RE: 2336 Mountain Rd. NW
Grading and Drainage Plan
Engineer's Stamp Date: 05/06/21
Engineer's Certification Date: 08/31/21
Hydrology File: J13D214

Based upon the information provided in your submittal received 09/01/2021 and site photos sent on 09/01/21, the Grading and Drainage Plan is approved for Building Permit and Building Pad Certification for 2336 Mountain Rd. NW. Please attach a copy of this approved plan in the construction sets for Building Permit processing along with a copy of this letter.

DRAINAGE AND TRANSPORTATION INFORMATION SHEET (REV 6/2018)

ENGINEER'S SEAL 5/6/21 DAVID SOULE P.E. #14522	LOT 279 MOUNTAIN RD	DRAWN BY: WCVJ
	GRADING AND DRAINAGE PLAN	DATE: 5-04-21
 1606 CENTRAL AVENUE SE SUITE 201 ALBUQUERQUE, NM 87106 (505) 872-0999		210210047-LAYOUT-5-04-21
		SHEET #
		JOB # 21021047

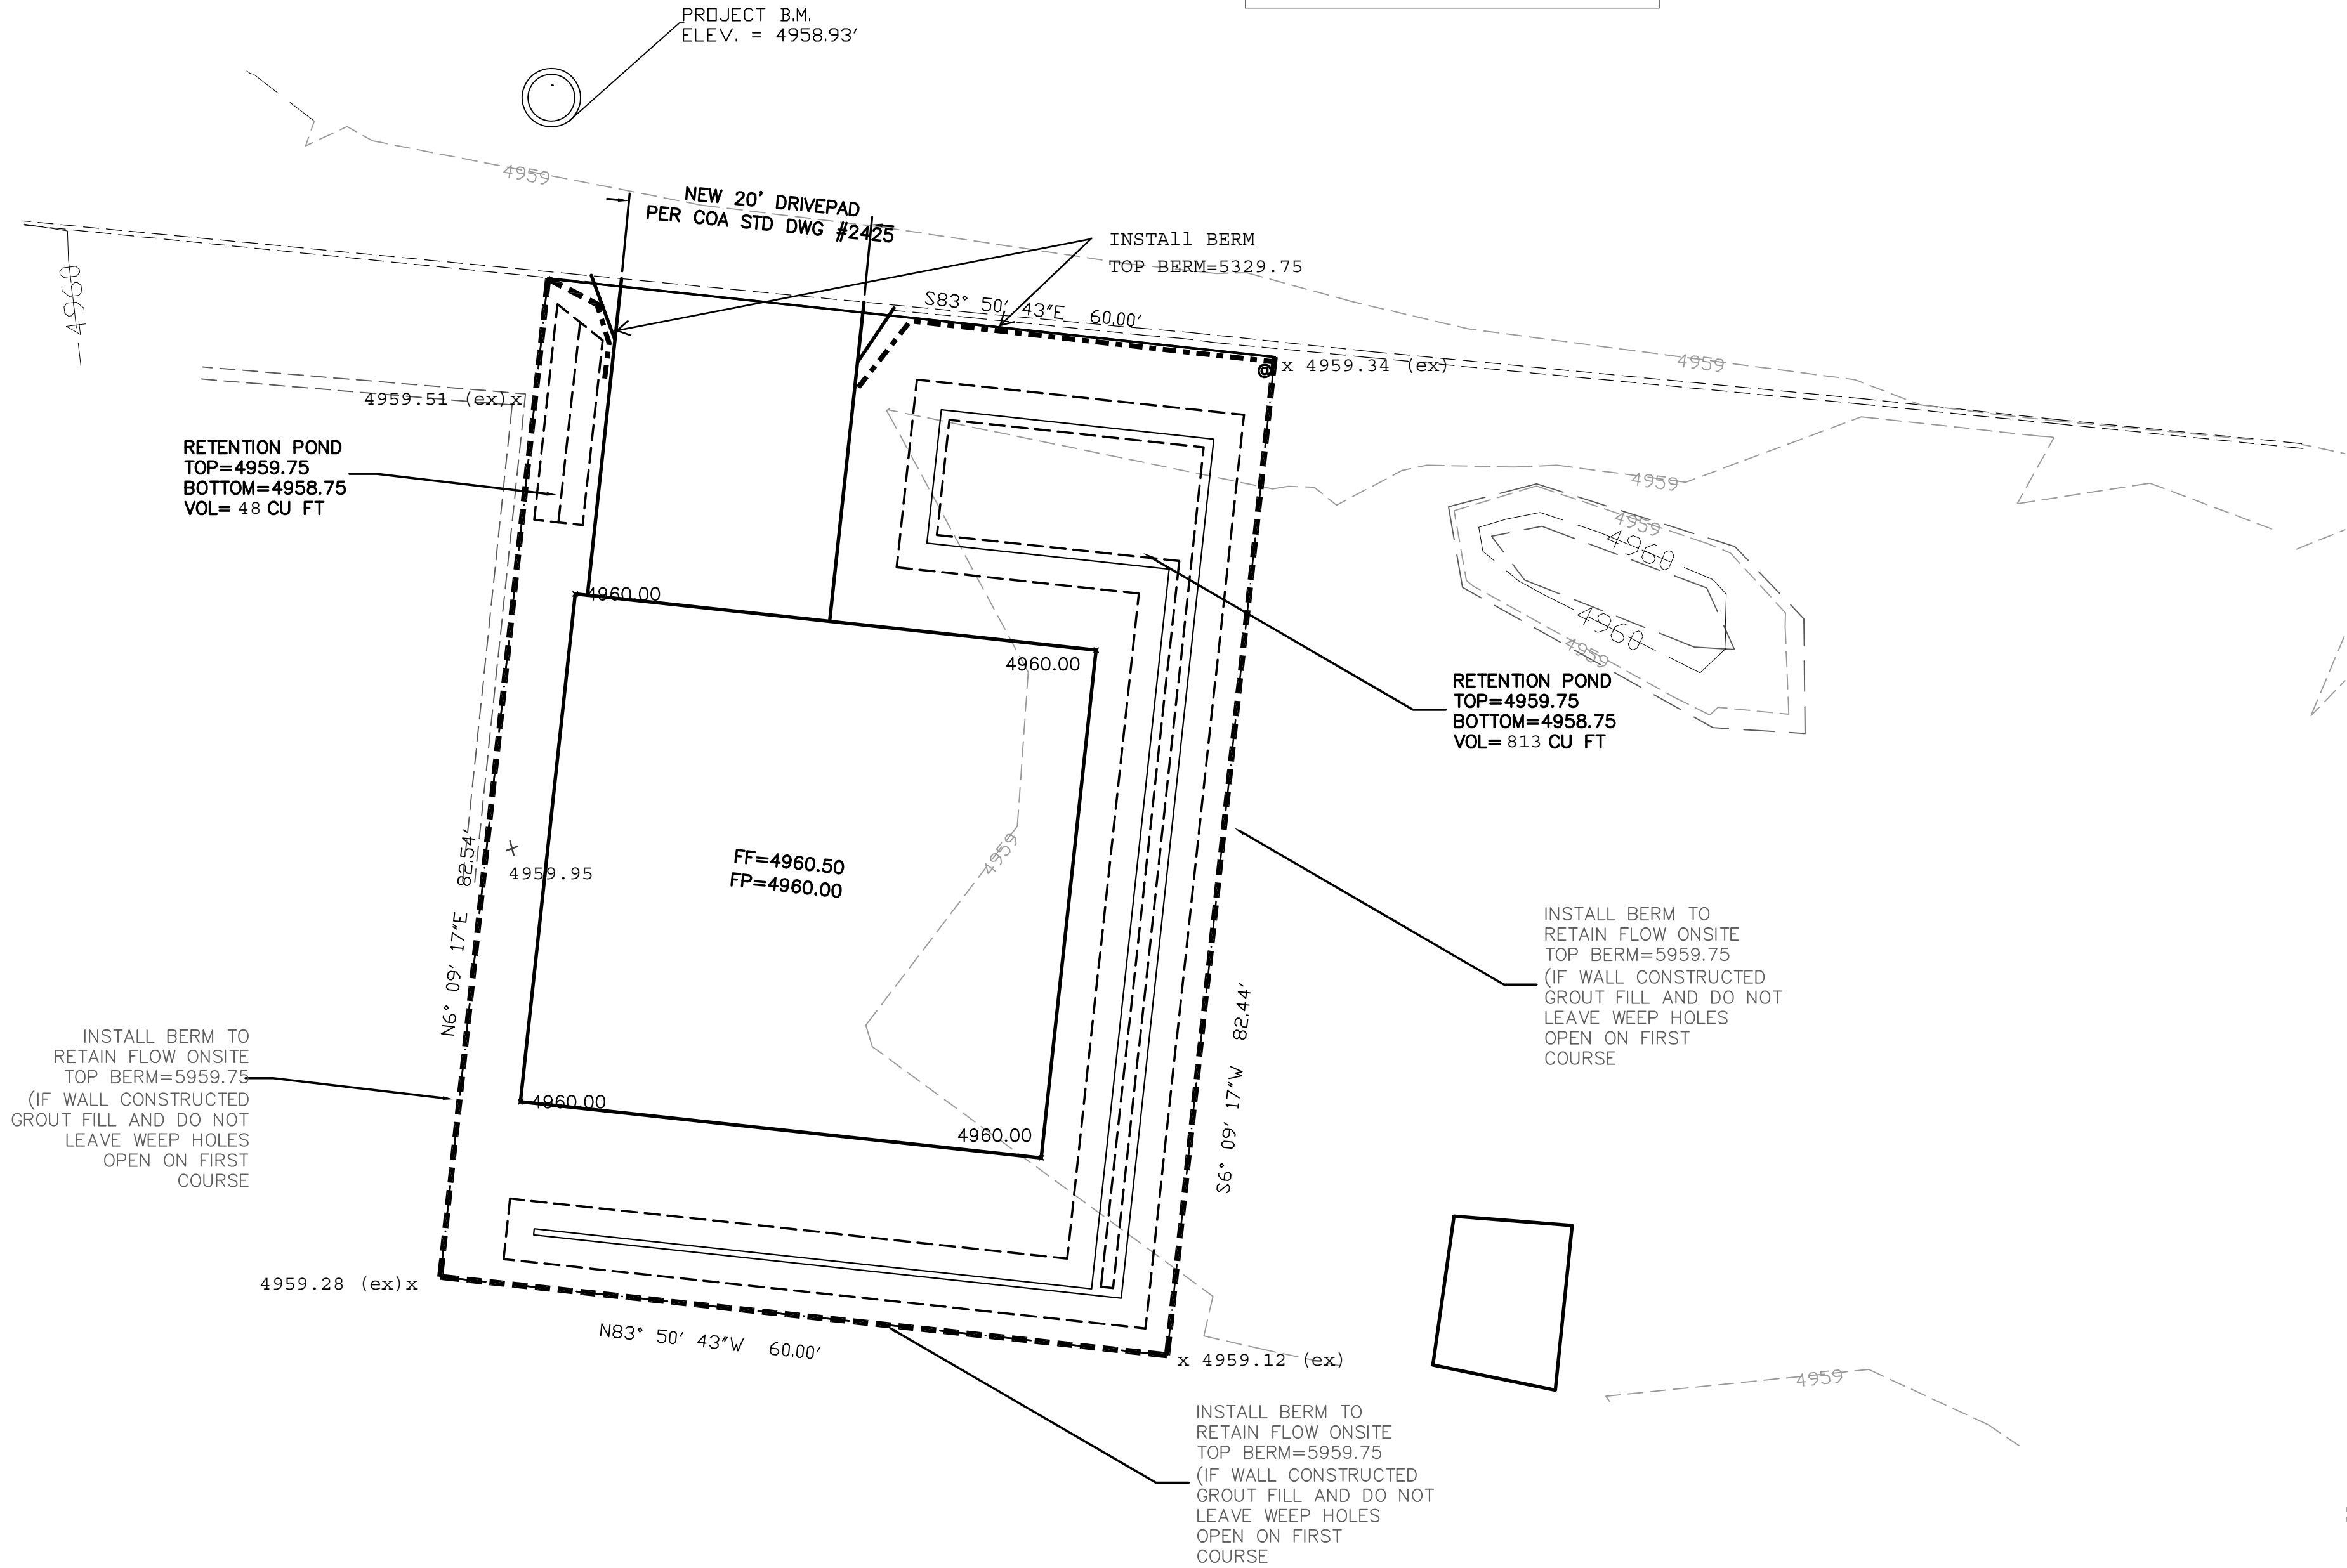
Prior to approval in support of Permanent Release of Occupancy by Hydrology, Engineer Certification per the DPM checklist will be required.
